Permit Number: 081249

**Subject: Plan Review for Permit # 08-1249 – 2nd memo
158 Grant St. CBL: 053 C010001**

**Subject: Plan Review for Permit # 08-1249
158 Grant St. CBL: 053 C010001**

RATED WALL ASSEMBLY DETAILS FOR 158 GRANT STREET-

TWO HOUR RATED WALL SECTION

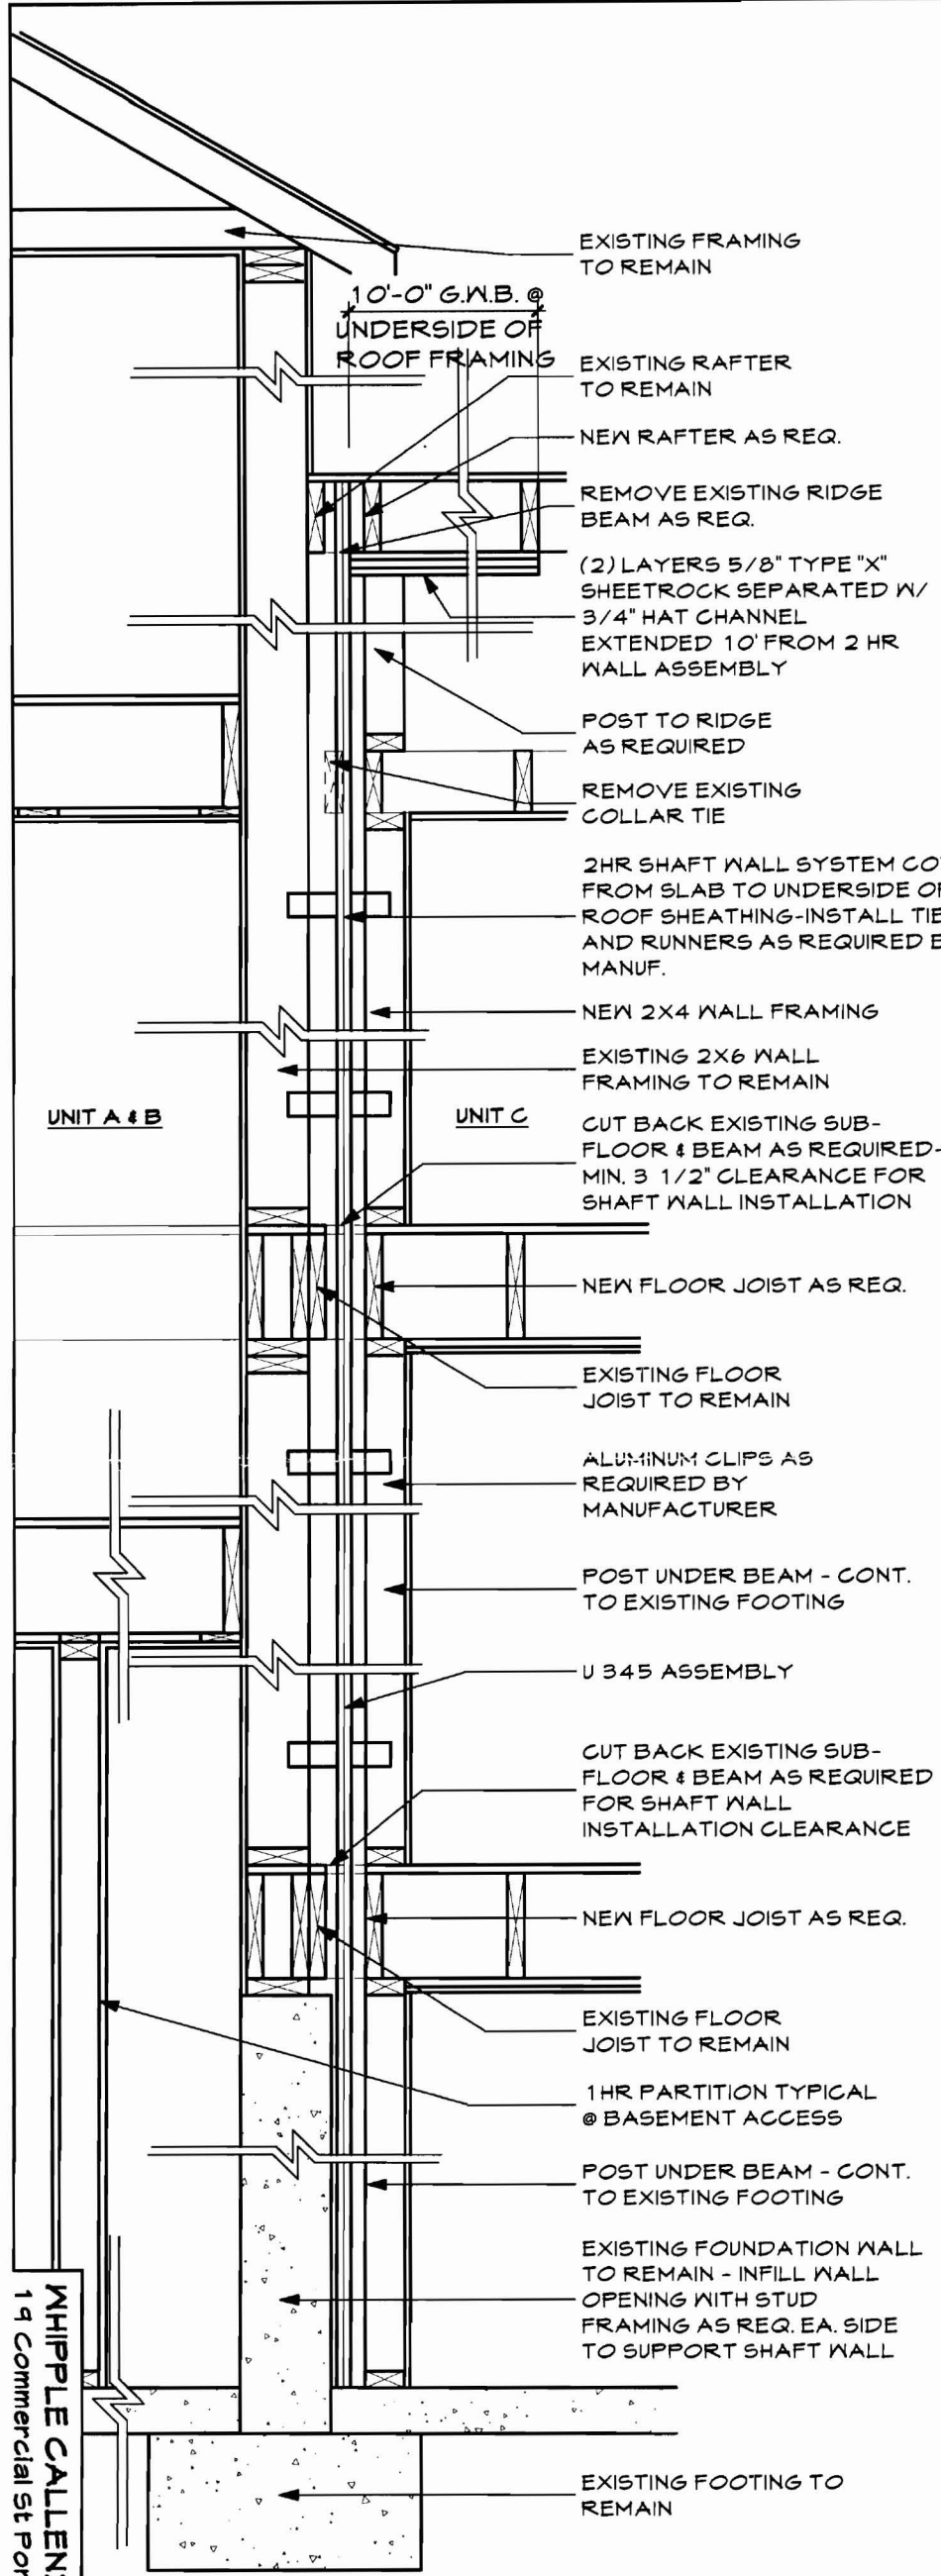
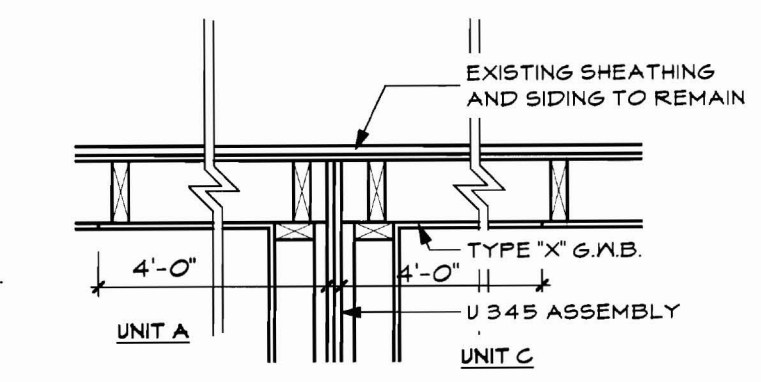
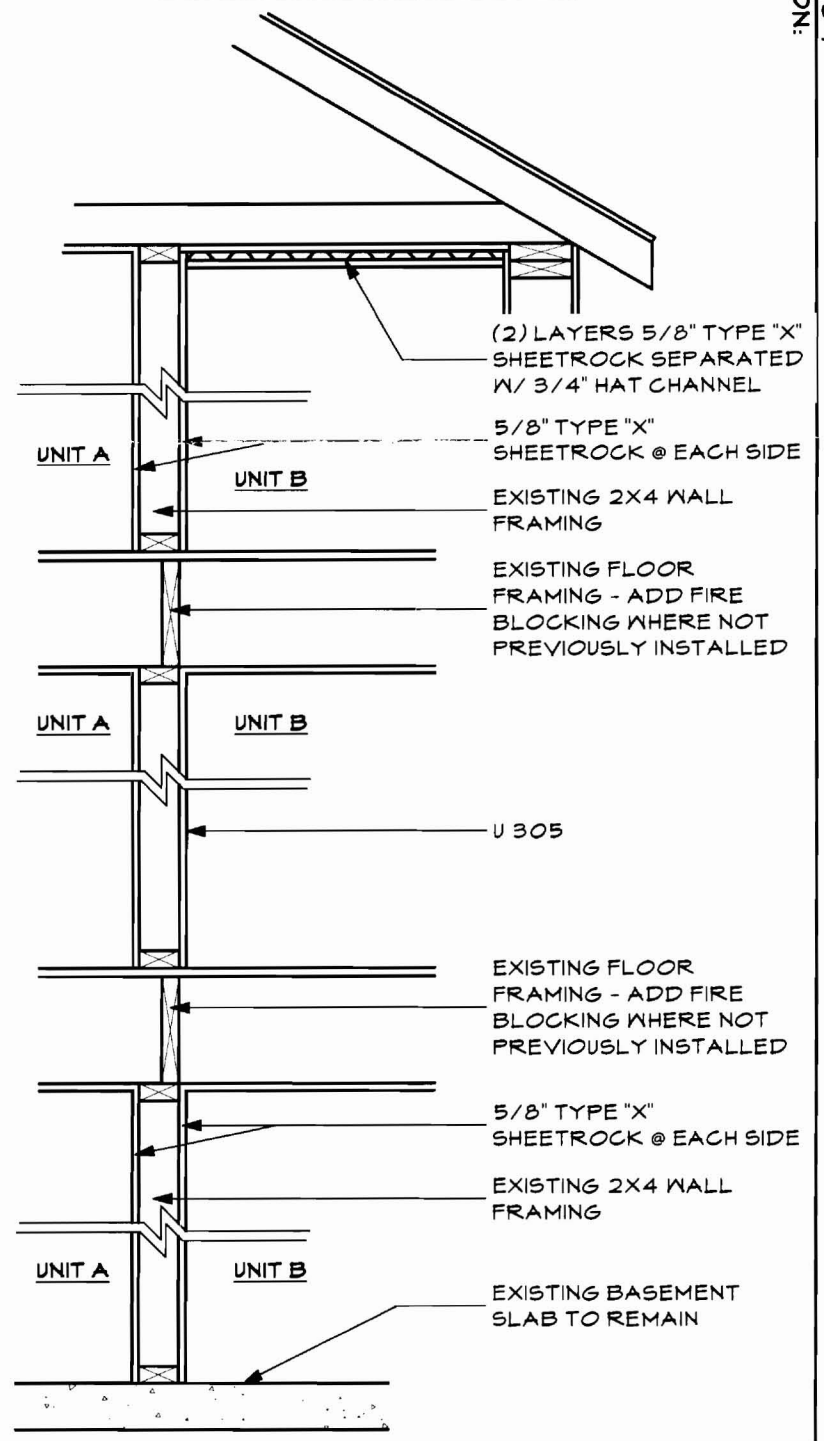
1. I have stamped the detail with my professional seal.
2. Please refer to the attached code sheet regarding the issue of rated parapet wall between the units- I would like to exception 1 section 705.6.1. Rather than a parapet wall, we will install a 1 hour rated assembly at the underside of the lower roof framing, 10' in from the 2 hour rated wall.
3. We have indicated on the detail the 1 hour rated ceiling at the stair to the basement from the driveway side as well as the 2 hour wall to exterior wall detail.
4. I propose we install a 2 hr. door assembly with a closer at the recessed entrance door to the middle unit to keep the rating continuous. I have talked to Kamco and they can provide this door with supporting documentation.
